53132A-05

<u>SERVICE NOTE</u>

53132A - 225 MHz Counter

Optional repair (see picture):

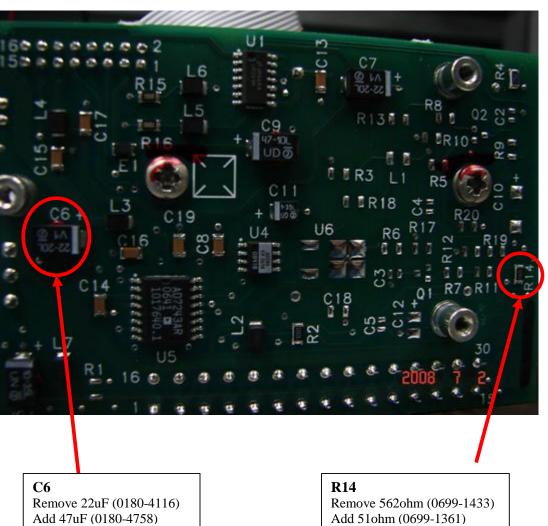
A manufacturing change to the oscillator, part numbers 10811-60160 (option 010) and 10811-60260 (option 012), causes a failure at power-on self test if the newer oscillators are replaced on to time base (A6) boards that have an EDC code less than 4829 on the board.

- Remove R14, 562ohm resistor and replace with 51ohm resistor (0699-1361).
- Remove C6, 22uF capacitor and replace with 47uF capacitor (0180-4758).

Add 51ohm (0699-1361)
